ANN ARBOR HISTORIC DISTRICT COMMISSION

Staff Report

ADDRESS: 526 Fifth Street, Application Number HDC25-0057

garage with an accessory dwelling unit above.

MAIN FLOOR
SCALE: 1/4" = 1'-0"

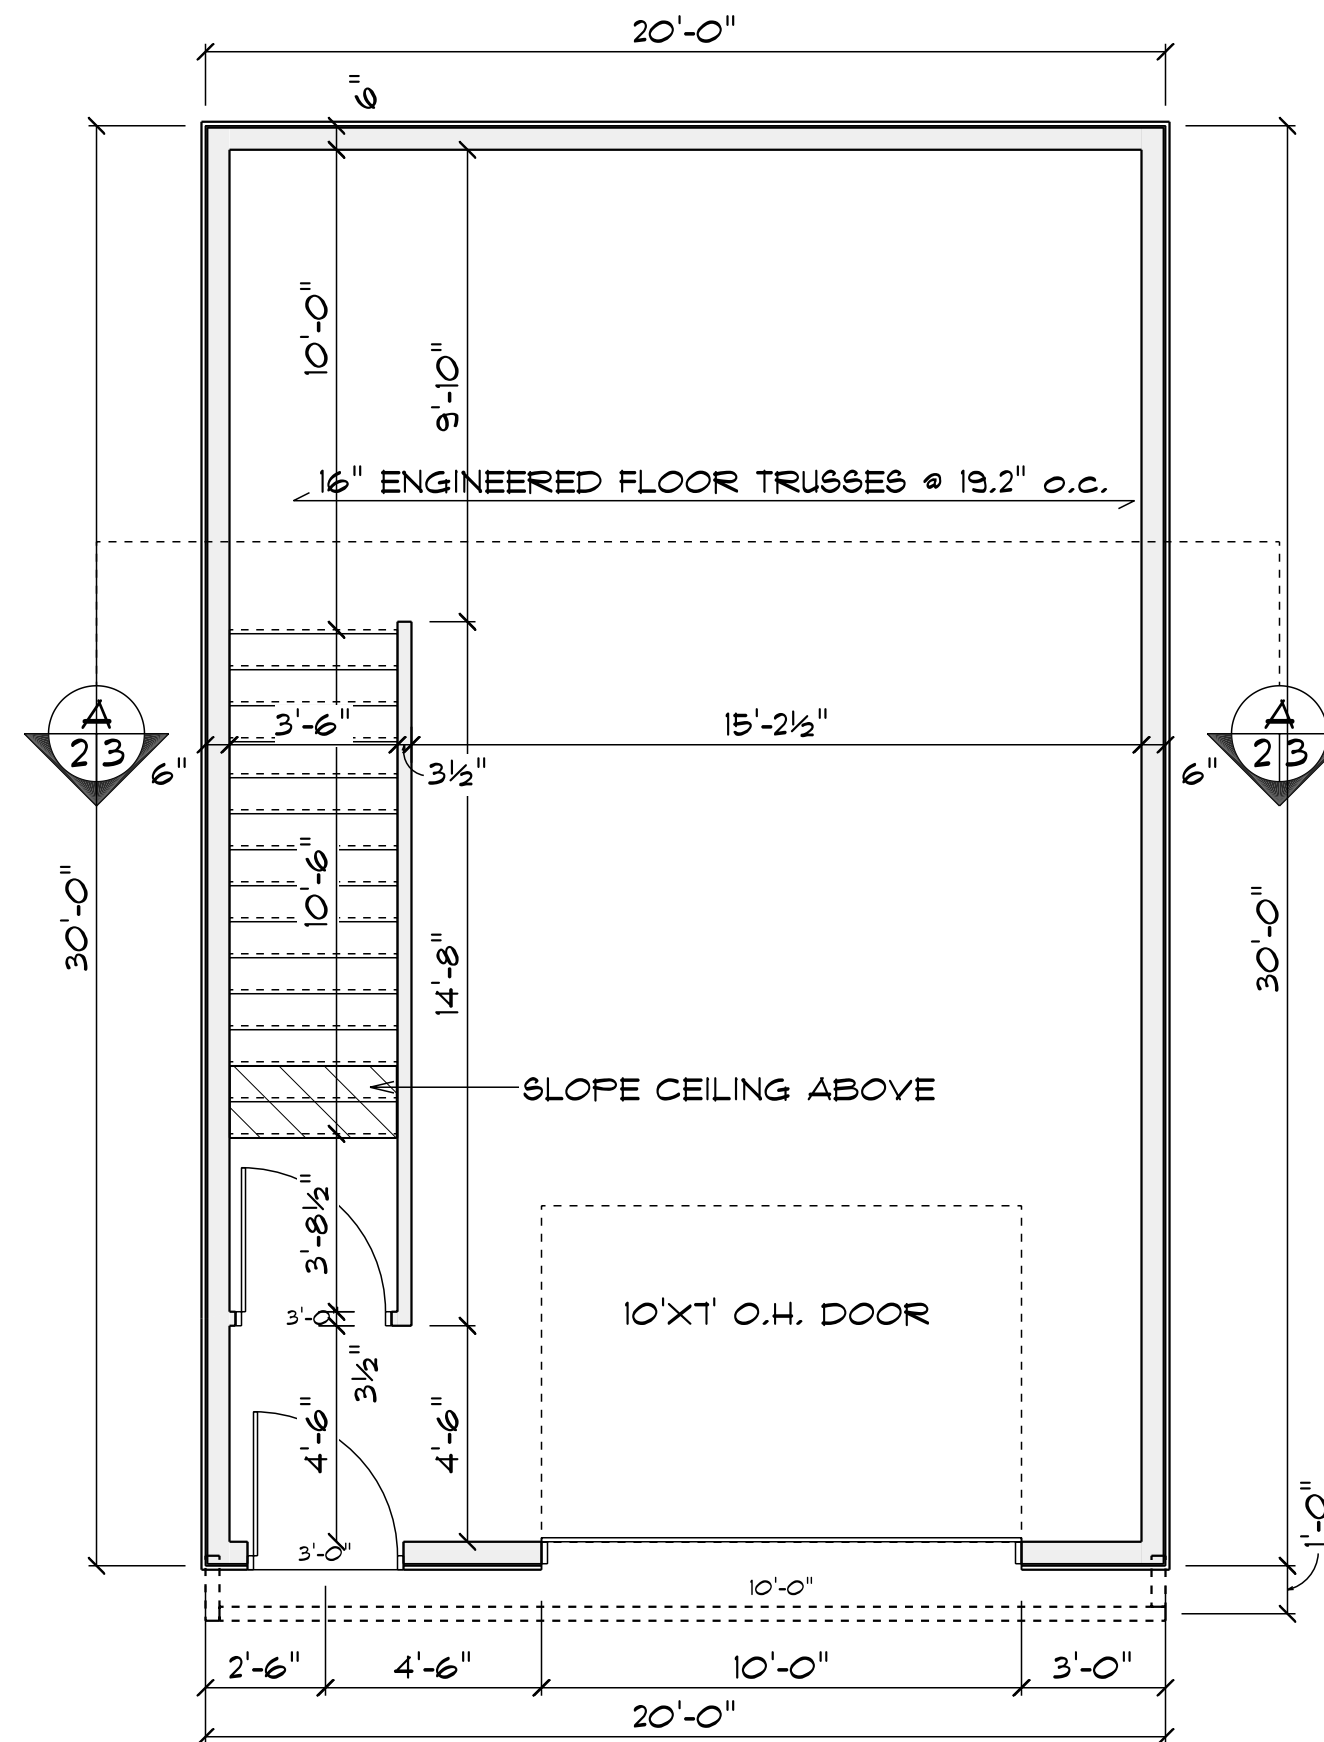
4. Windows are Andersen 400 series clad four-over-one and six-over-one plus one horizontal single sash on the rear elevation and sizes are shown on the floor plan sheet. Staff has requested dimensions and material for the person door, and material for the 10' by 7' overhead door.

CROSS SECTION A-A

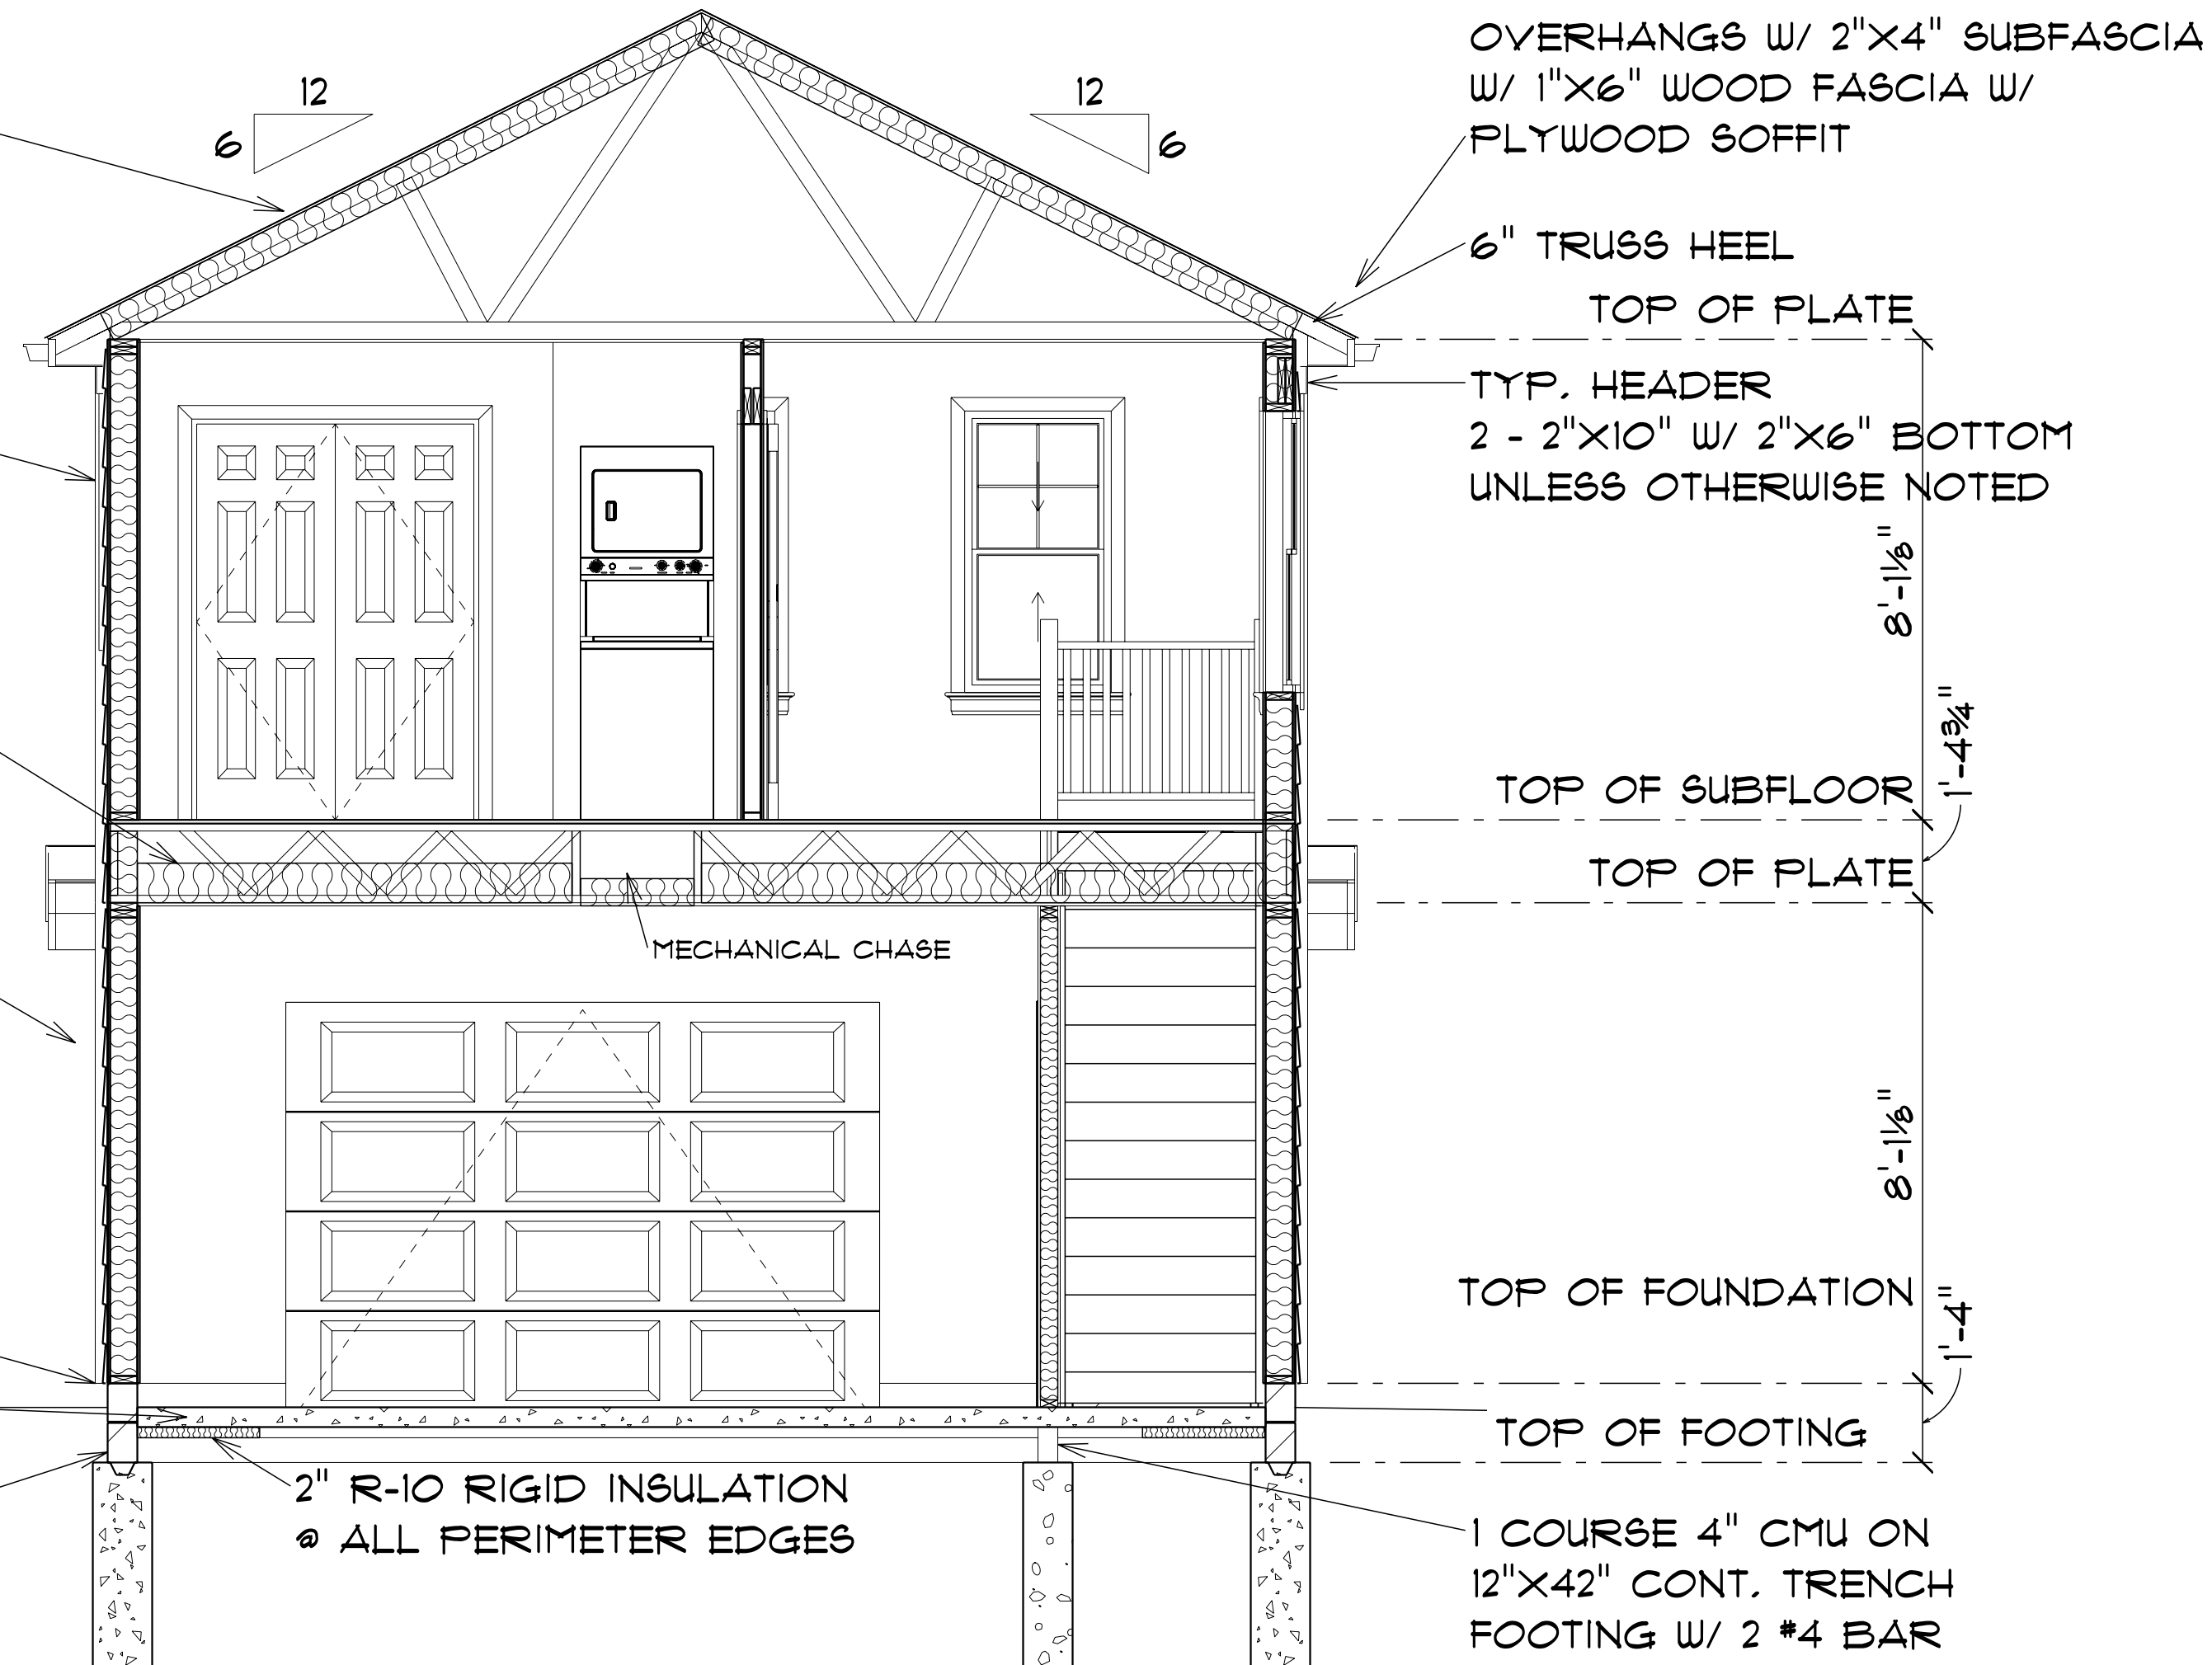
3. The building is 21' tall to the midpoint of the gable (which is how the height of accessory structures is measured by zoning) and the roof pitch is 6/12. The foundation is two courses of concrete masonry units with a continuous trench footing. Cladding is wood lap siding with 4" exposure, with wood corner trim. There is a trim board under the eaves and gables, both of which have a 12" overhang. A small shingled awning runs across the front above the garage and person door.
